**NM - 29**

**SOUTHWEST WATER DISPOSAL**

**SITE ASSESSMENT  
"SKIMMER PIT"  
SOUTHWEST WATER DISPOSAL SITE  
SE/4 SW/4 SECTION 32, T30N, R9W  
SAN JUAN COUNTY, NEW MEXICO**

**August 20, 1993**

TOPO MAP  
AND  
WATER SPRAY SYSTEM  
PLAN VIEW

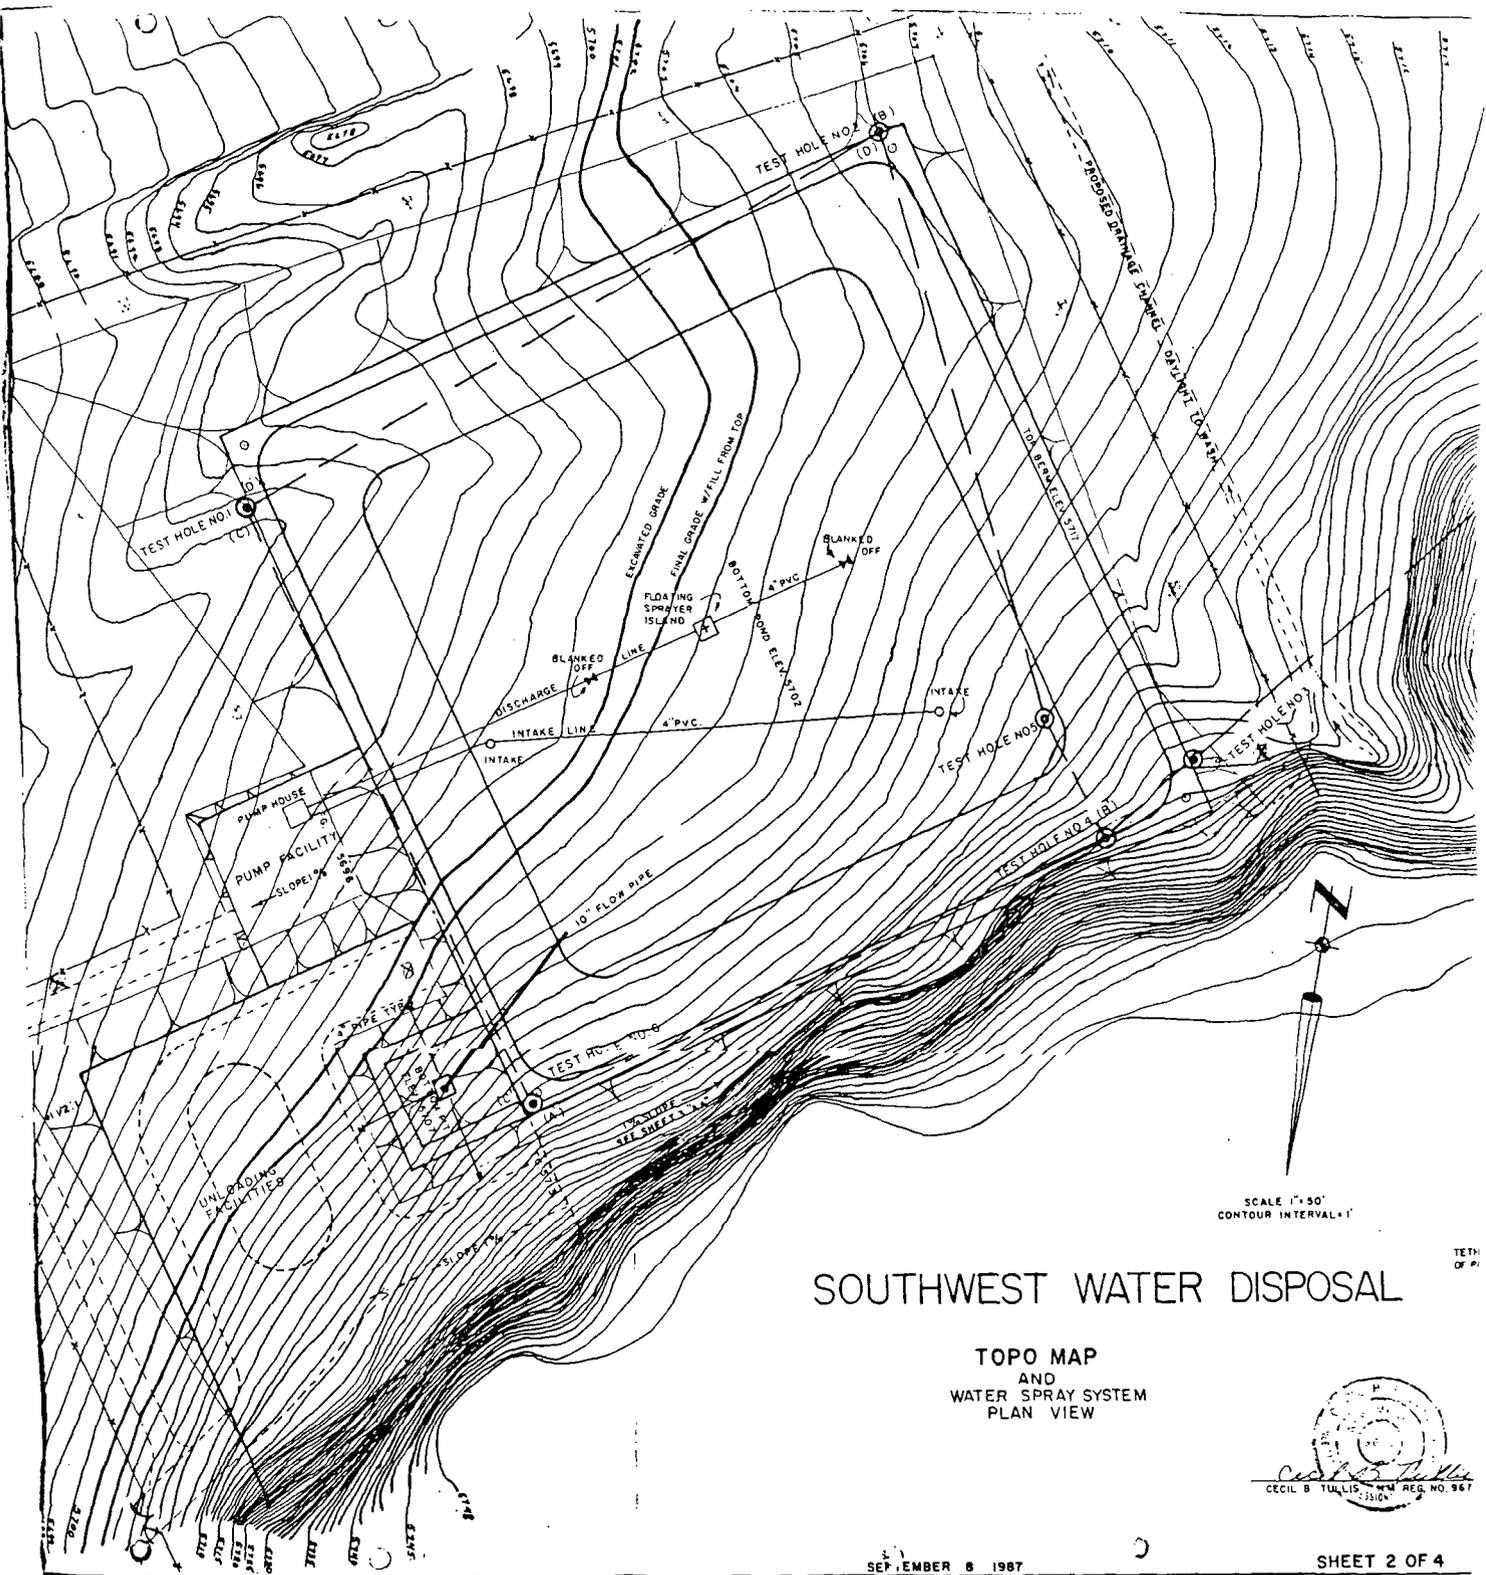
We have reviewed the plans and specifications in your application dated July 14, 1987 (received August 5), for the above-referenced evaporation pit. Before approval for the pit can be granted, a number of major geologic, hydrologic and operational concerns must be addressed.

2. No engineering details for construction of the skimmer pit were provided. Since it is to be used for oil recovery, it must be lined, or tanks used for separation pursuant to CCD Rule 310 which prohibits oil retention in earthen reservoirs or open receptacles. If a liner is used, please provide engineering diagrams for construction of the pit, including details on the liner (type, thickness and installation), size and construction of beams (size of lifts to be compacted, etc.), and piping and pumps to the main pit and storage tanks. Also include detailed diagrams and schematics for any tanks at the facility, along with their piping and operating procedures. The application states the inside slope of the skimmer pit would be 1:1. That steep a slope is unacceptable for approval. Tanks, as used at Basin Disposal, would seem to be an easier method to use to separate the fluids.

3. If fluids will be unloaded directly into the skimmer pit, precautions must be taken to prevent damage to the berms and pit walls. Please detail unloading procedures and construction plans that will prevent damage at this point and at the end of the discharge pipe between the skimmer and evaporation pit. Clarify maintenance plans on both inside and outside surfaces for all berms at the facility.

5. Please provide a schematic of the plumbing system to be used in the pump house and spray system.
6. No engineering details for construction of the evaporation pit were provided. Please provide engineering diagrams for construction of the pit, including details on size and construction of the berms, amount of cut and fill, etc.

- 5) See design plans.
- 6) See attached. The dikes will be constructed in 6" lifts or as necessary to ensure 95% proctor compaction.
- 7) The geologic information you have requested is attached. Cross sections have been made and revealed a 2° apparent SE dip. Three different samples were taken from the three soil types to be utilized in the construction of the pond. As mentioned earlier, the pond will have a minimum permeability life of 673 years. The point that is most vulnerable to a leak is that point in the bottom of the pond where there is only cut, as the compacted clay depth will be only three feet deep. However, this is the area where there will only be natural in-situ clay.
